2010 Annual Inspection of CCP Facilities and Ponds

Kingston Fossil Plant
Harriman, Tennessee

Prepared for:
Tennessee Valley Authority
Chattanooga, Tennessee

June 1, 2010

Plan View - KIF 2010
Annual Inspection - Dredge Cell

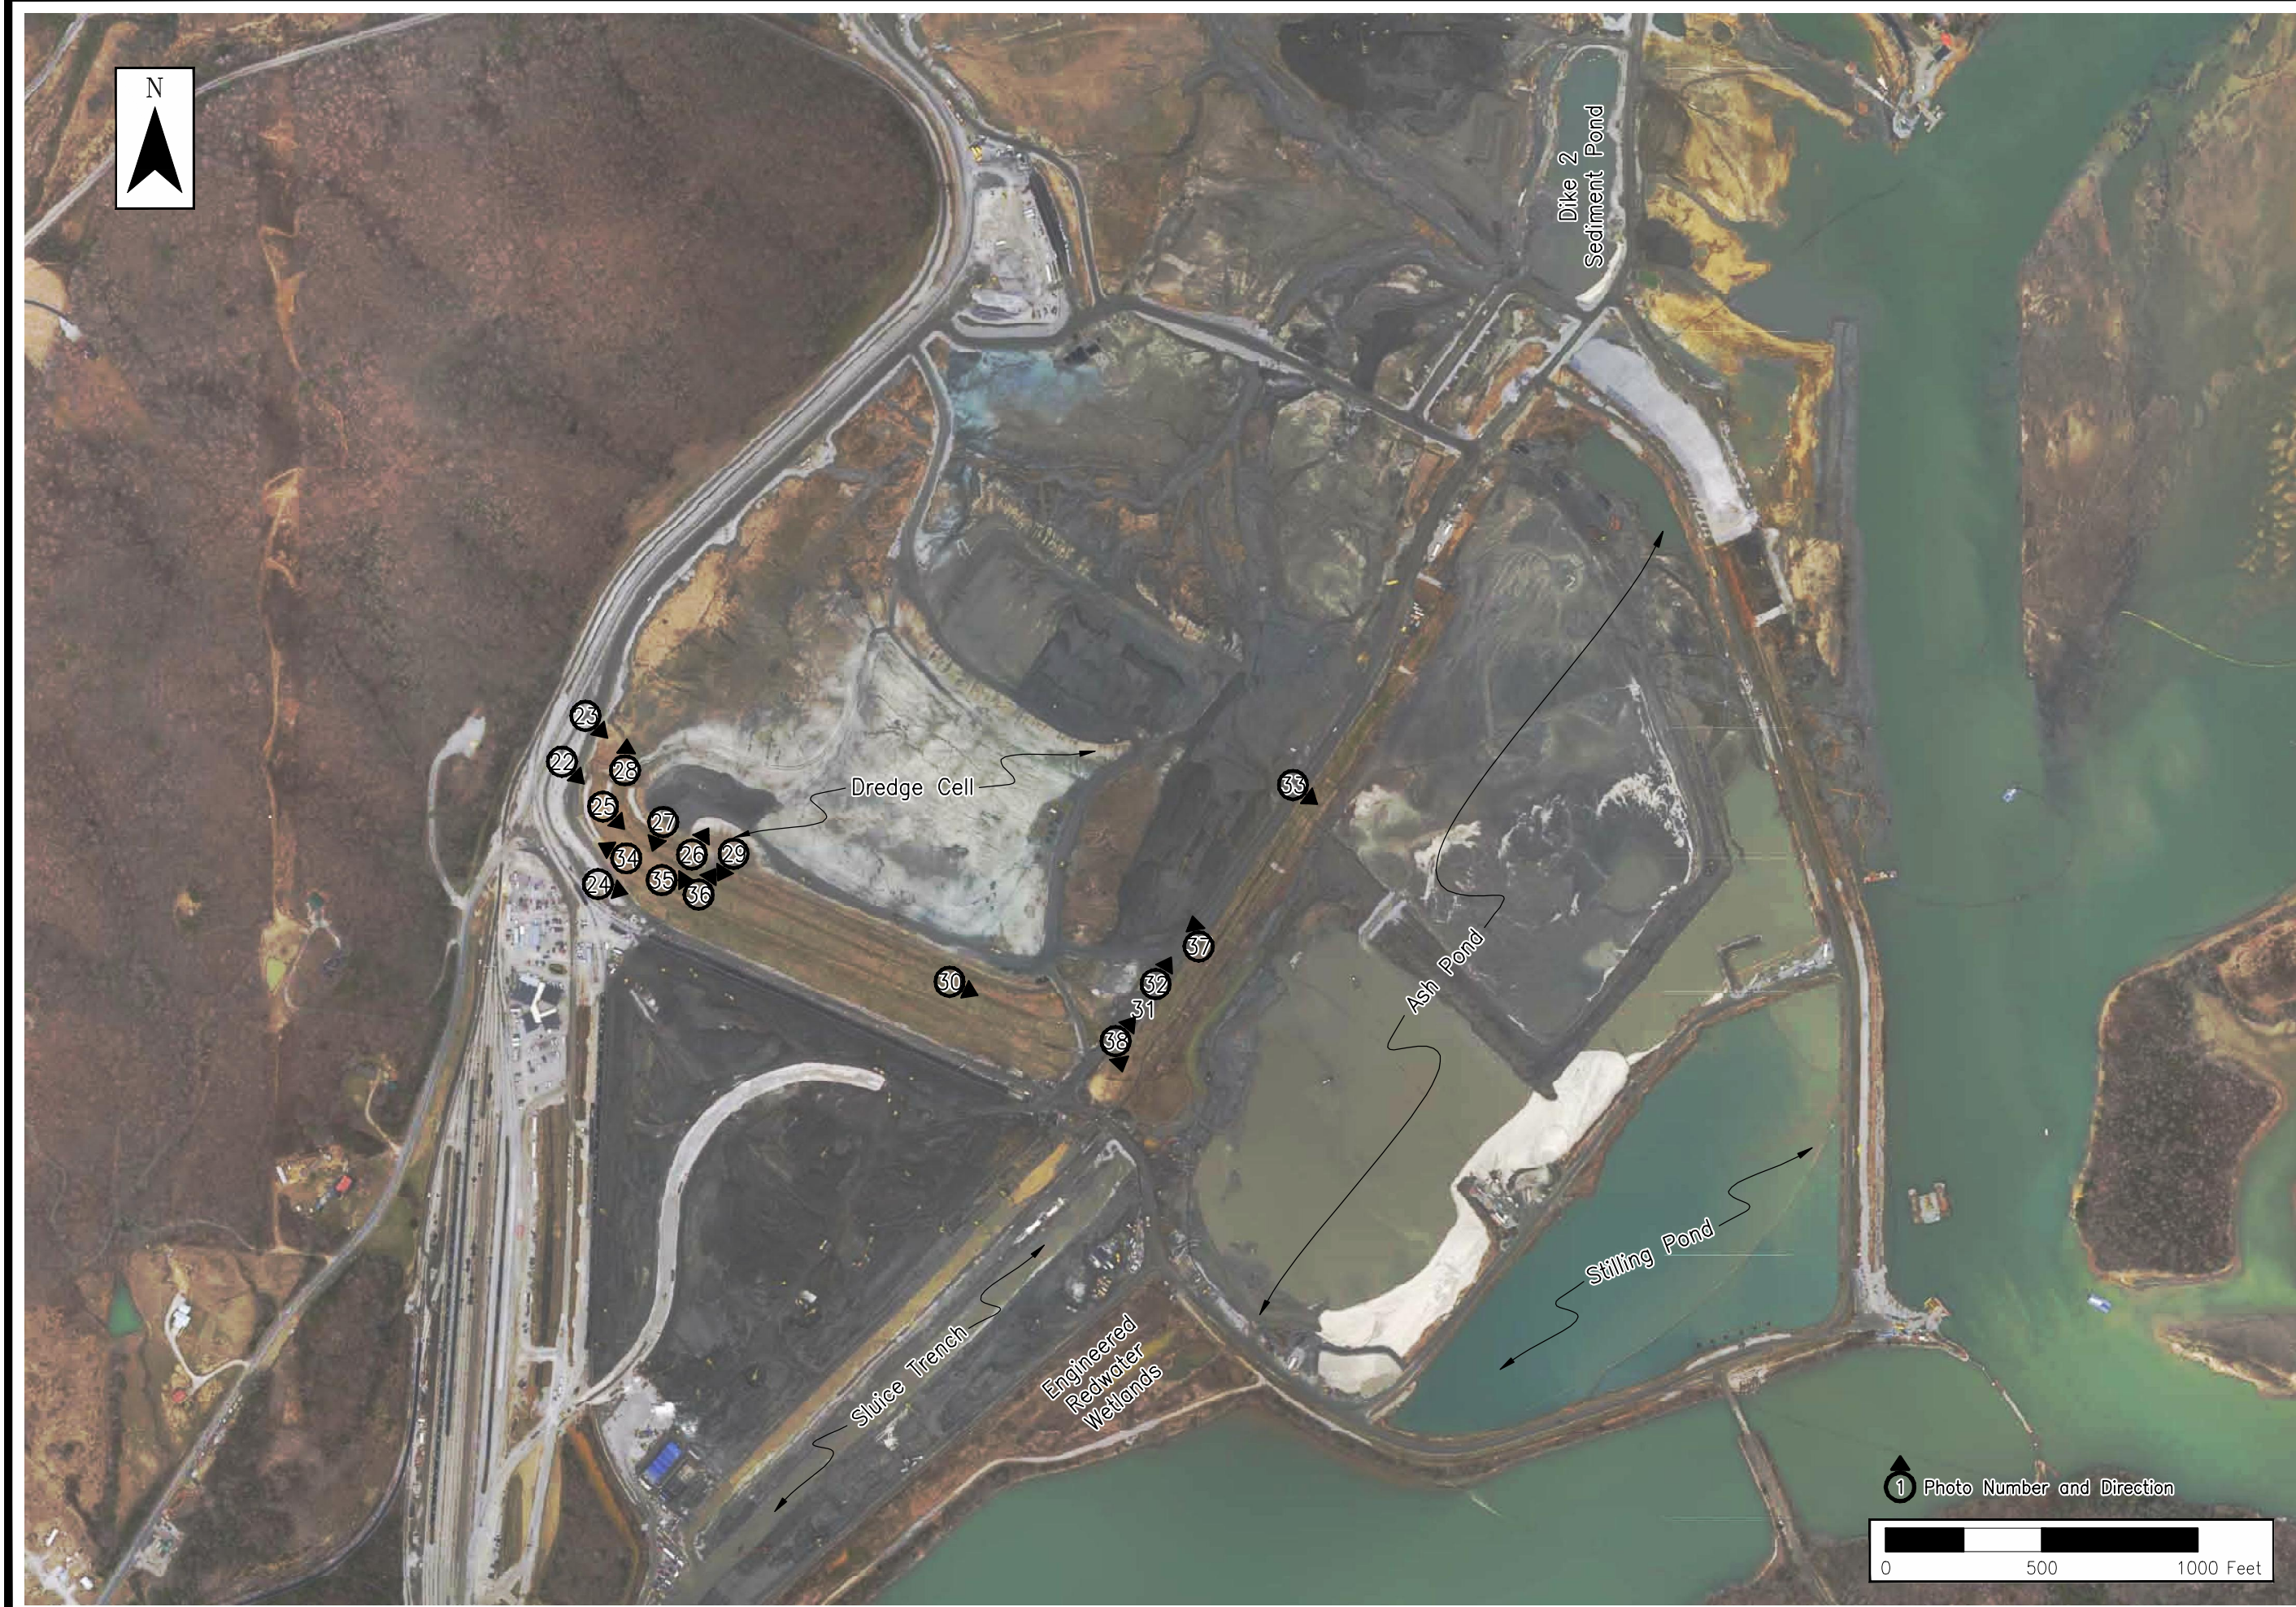
- Numerous areas of erosion and/or rutting with standing water were observed during the inspection include areas along both Dike C and Die D (Photos 27, 29, 30, 37, and 38). It is recommended that these areas be drained and/or subsequently filled/graded and in accordance with current site protocols for erosion repair and temporary vegetative cover. Filling should consist of placing select ash or clay and compacting with small compaction equipment, such as a jumping jack, or hand-held tampers. Some excavation may be required to create foundation benches to allow compaction to occur on level ground. Erosion control blankets should be used for the areas on sloping ground. (Priority 4)

- A few areas lacking adequate vegetation coverage were noted in this inspection along Dikes C and D (Photos 25, 27, 29, and 32). Re-seeding of these areas should be performed to re-establish vegetation growth. Erosion control blankets should be used since the areas are on sloping ground. (Priority 4)

- Some small trees and brush are located on the exterior slopes. It is recommended that trees and brush be removed from these slopes in accordance with the general guidelines shown in Enclosure I. (Priority 4)

- It is recommended that the erosion feature encountered in exposed ash (Photo 28) be excavated and re-filled with suitable ash materials in accordance with general site erosion control protocols. (Priority 4)

- It is recommended that the clogged drainage pipe (Photo 26) outlet be cleared and the pipe be evaluated to determine its current working condition and promote positive drainage. (Priority 4)

Plan View - KIF 2010 Annual Inspection
Engineered Redwater Wetlands

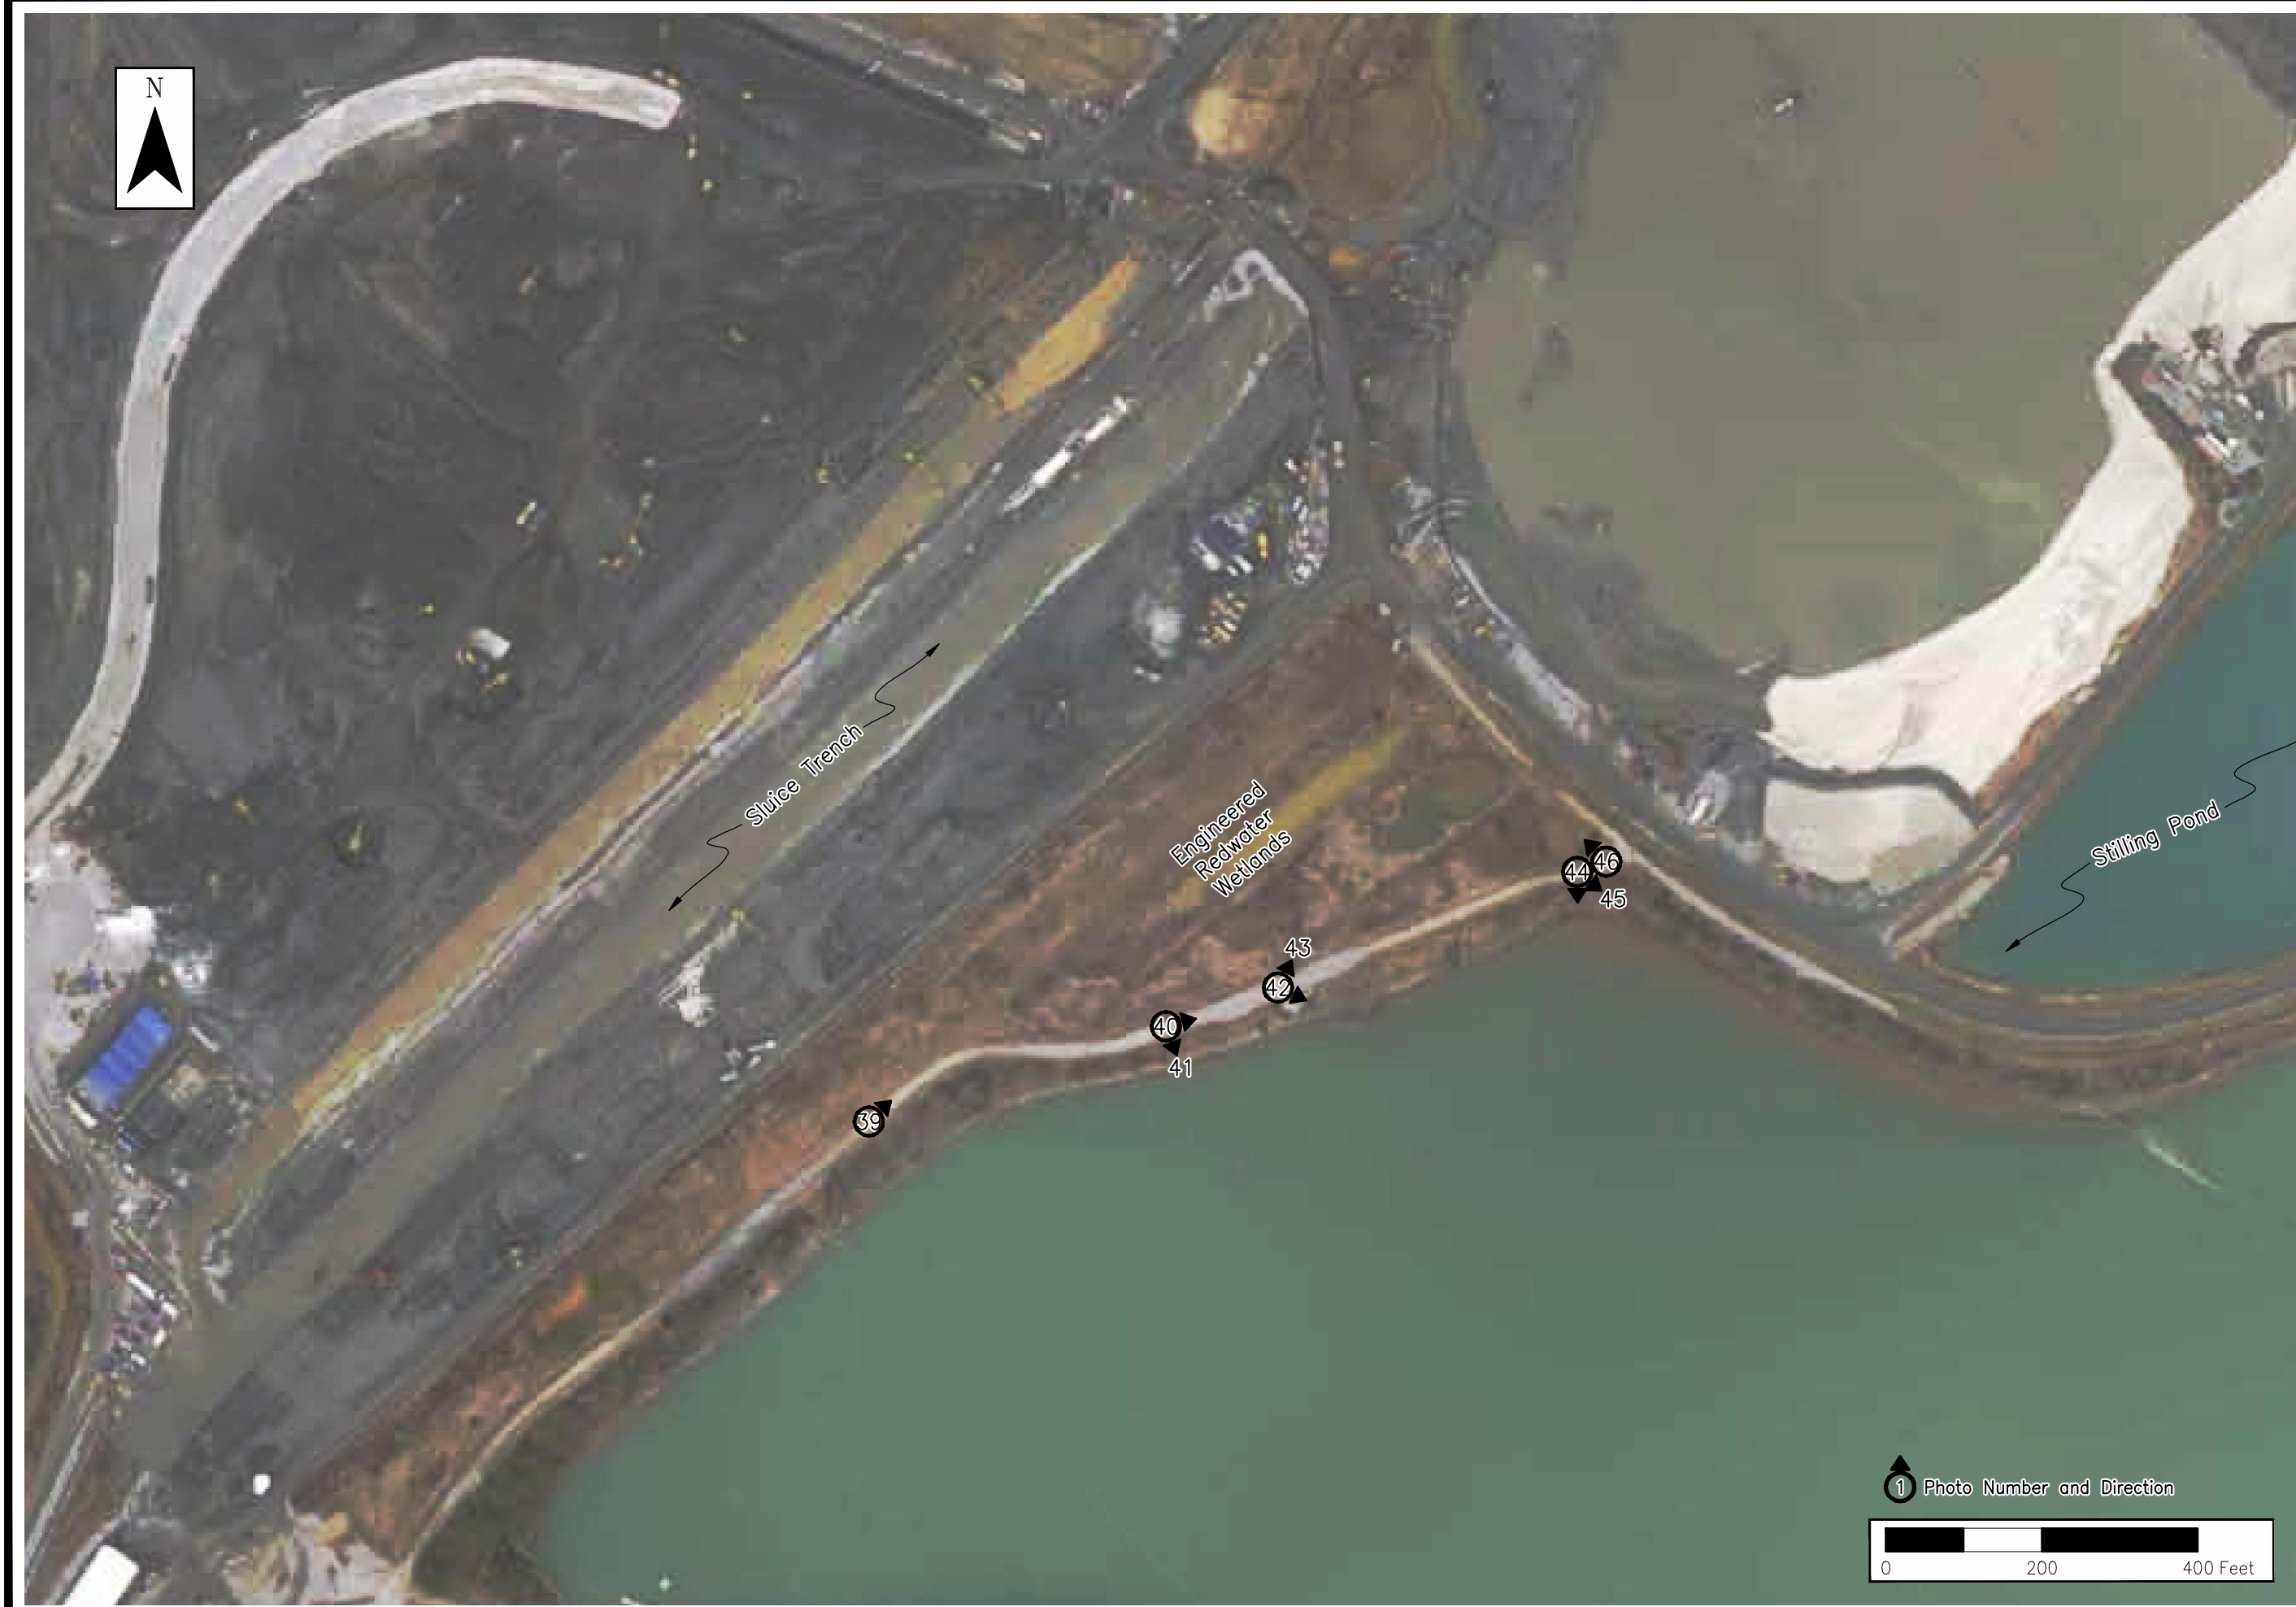
- Trees and brush are located on the interior and exterior slopes. It is recommended that trees and brush be removed from these slopes in accordance with the general guidelines shown in Enclosure I. (Priority 4)
- It is recommended that floating debris/vegetation observed within the discharge pump structures be removed so the pumps do not become clogged or damaged. (Priority 3)
- It is recommended that the seepage observed along the Intake Channel waterline continue to be monitored in the interim until mitigation designs are implemented in association with Ash Pond closure and plant conversion from wet to dry ash handling.
